# HCD PROPERTIES MINOR SUBDIVISION

### CONSTRUCTION DRAWINGS

Add text:  
PCD Filing No.:  
MS-21-008  
Added.

GRADING & EROSION CONTROL PLAN  
COVER SHEET

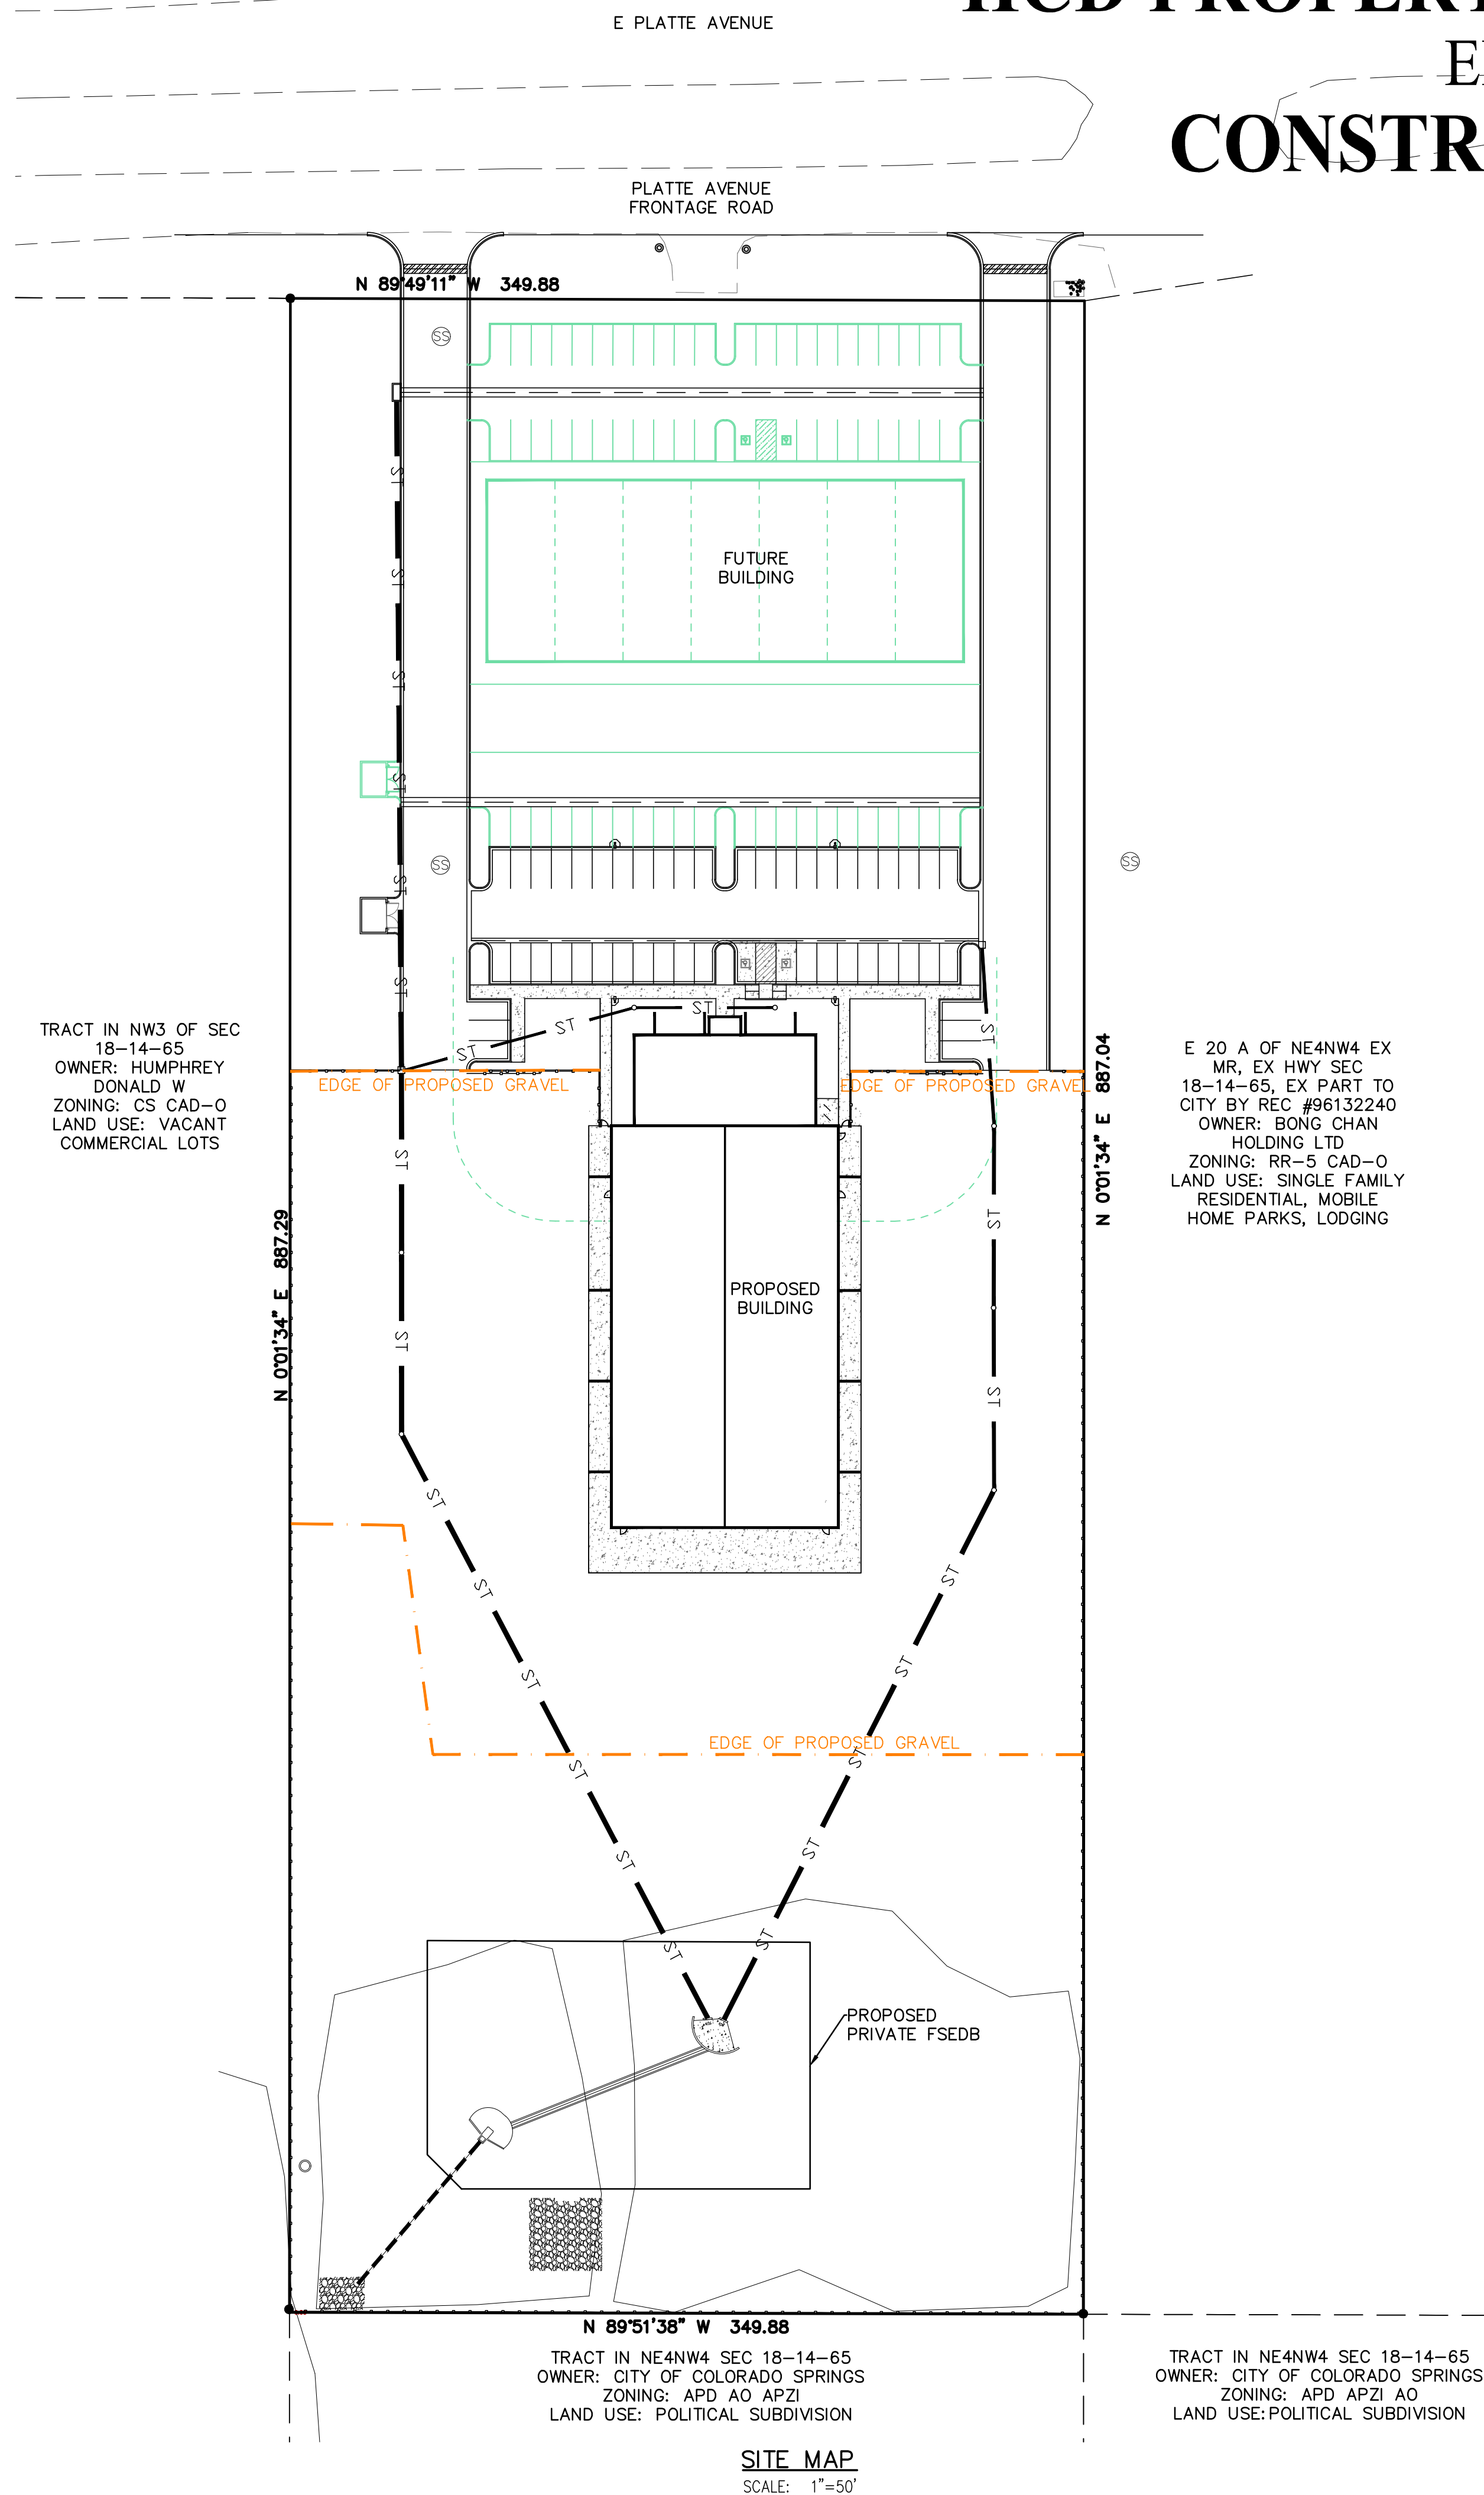
Remove from the minor subdivision application. This will be reviewed and approved with the site development plan application

Per Gilbert's comment above, my minor comments on subsequent sheets can be applied to when you upload these CD's for the site development plan. I did not complete my review, but wanted to leave these comments on here for you to make the revisions and then I don't have to make the same comments on the site development plan.

Include the 3 signature blocks that are shown on the GEC Checklist

HCD PROPERTIES MINOR SUBDIVISION  
6201 E PLATTE AVE.  
CONSTRUCTION DRAWINGS  
EROSION CONTROL PLAN

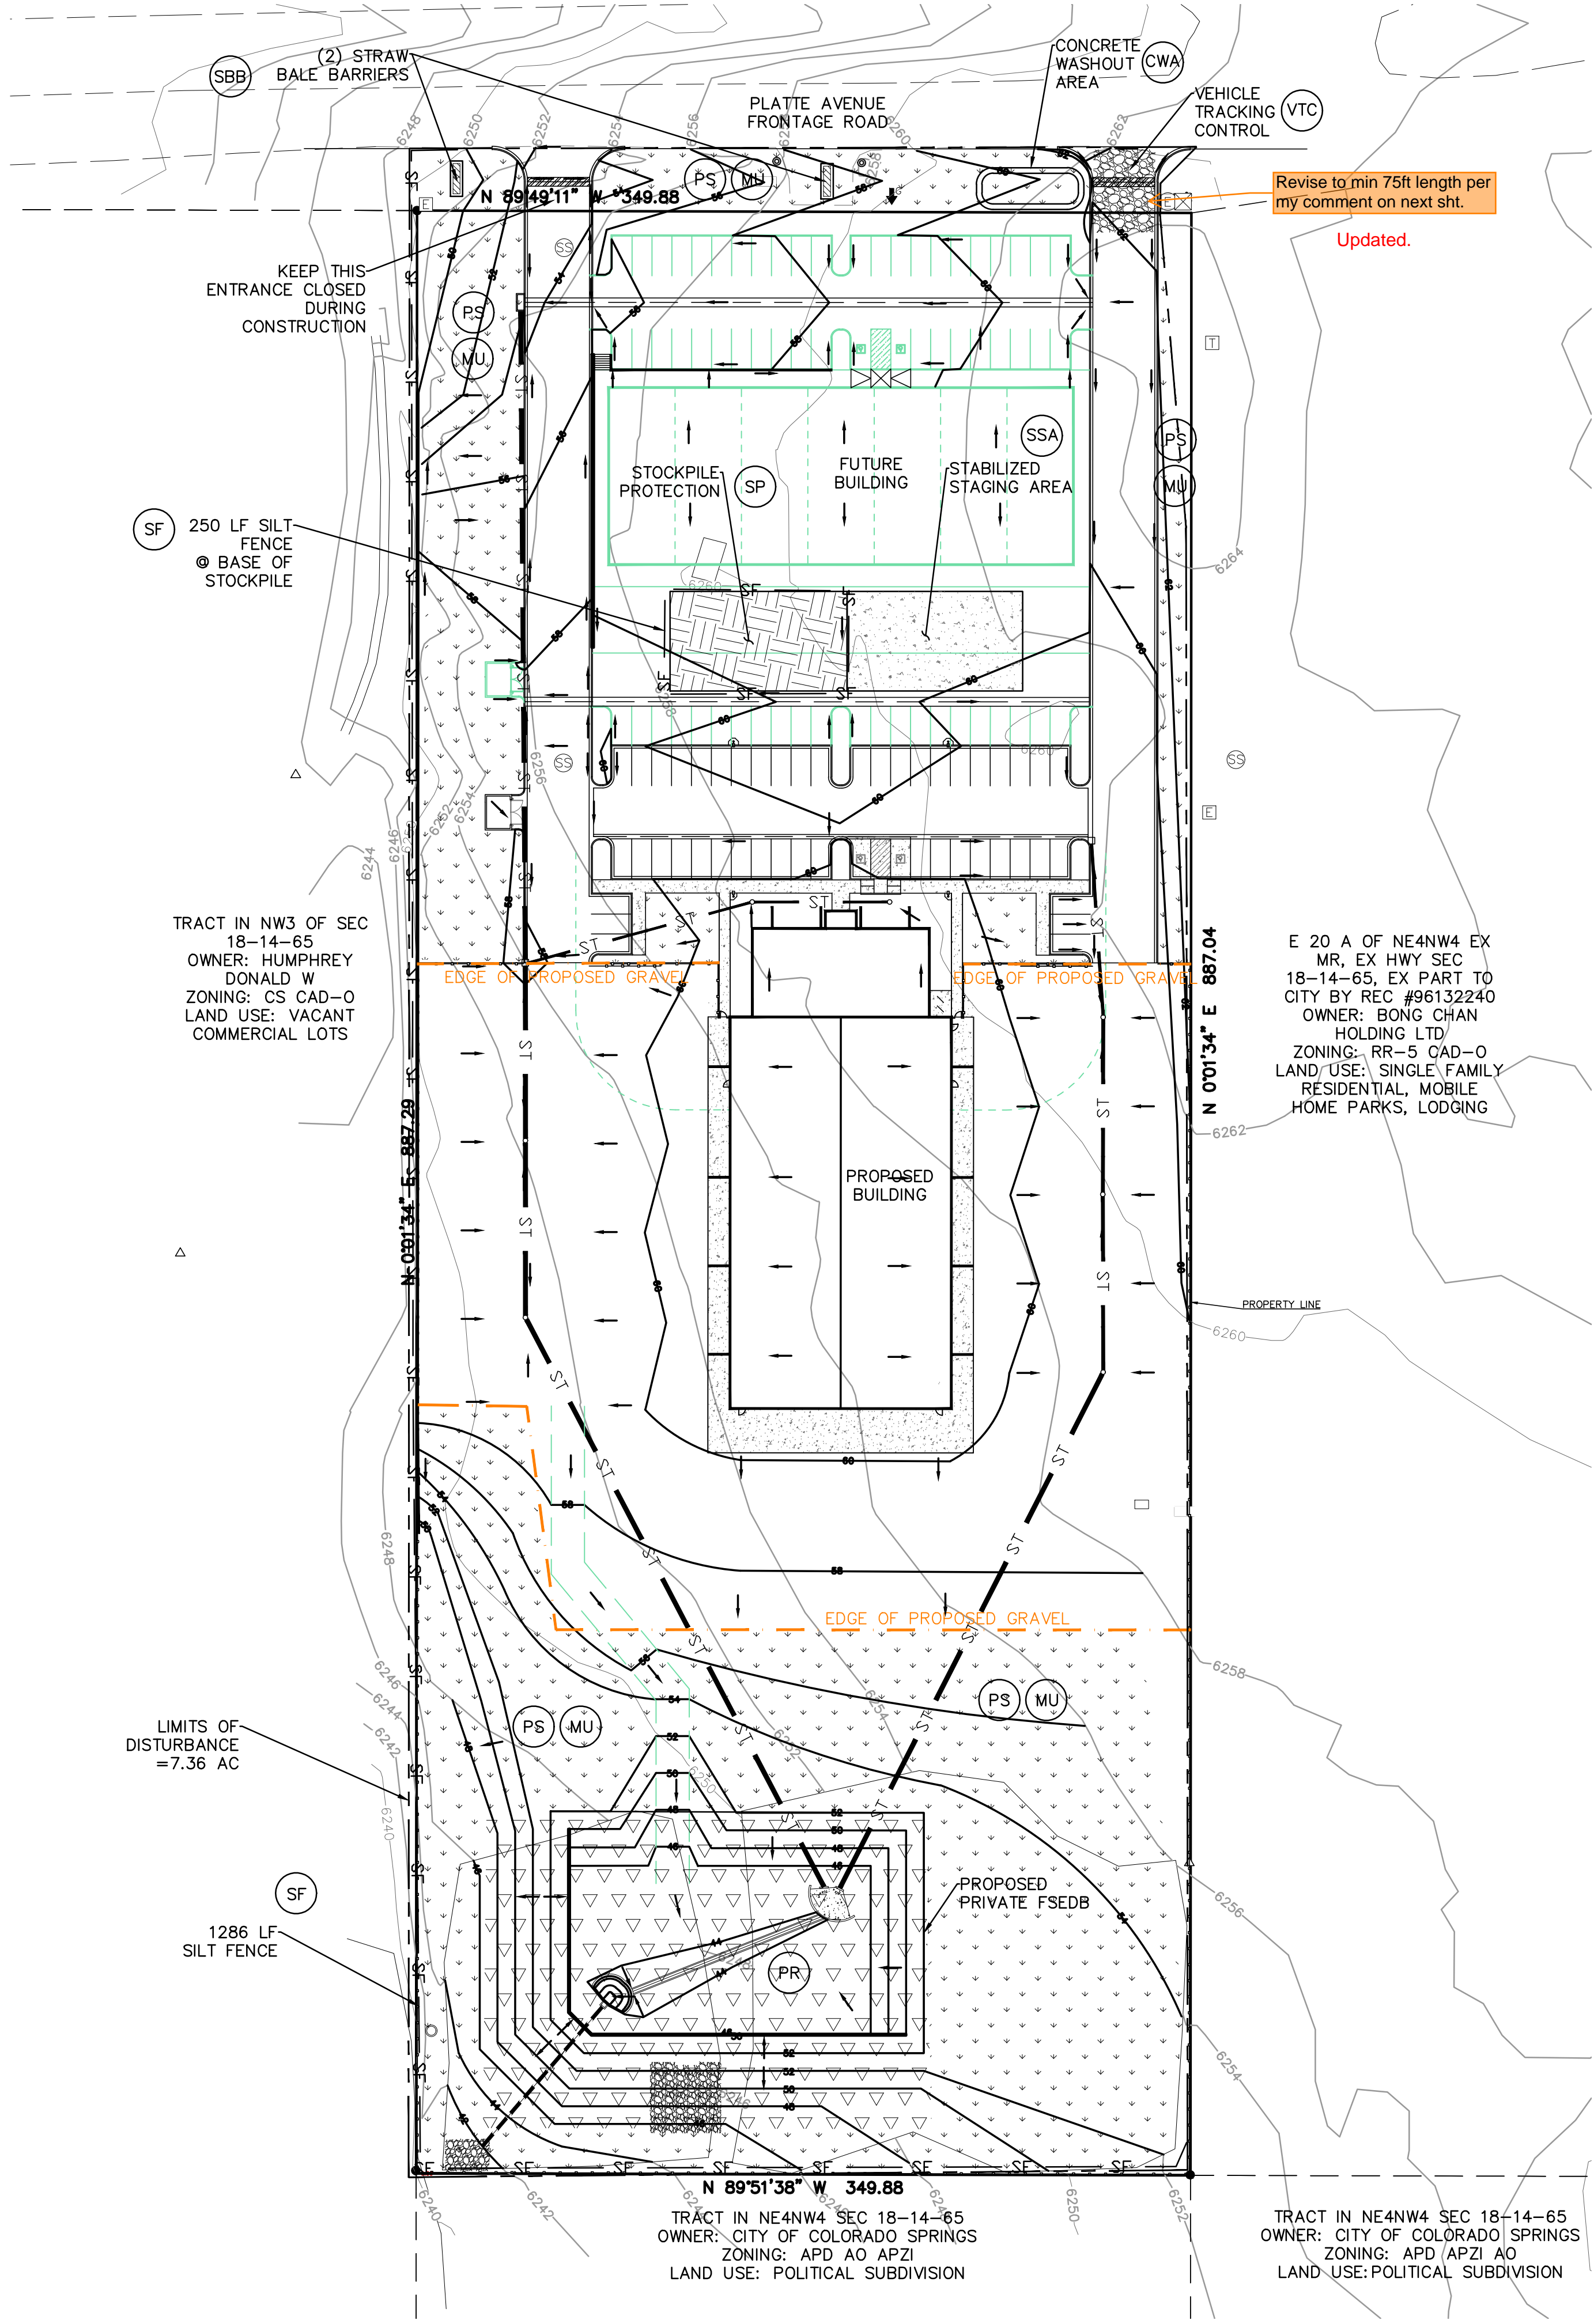
If "limits of disturbance" and "construction boundary" are the same, change to "limits of construction/disturbance" or otherwise show as separate linetypes for each on the legend and figure.

Updated.
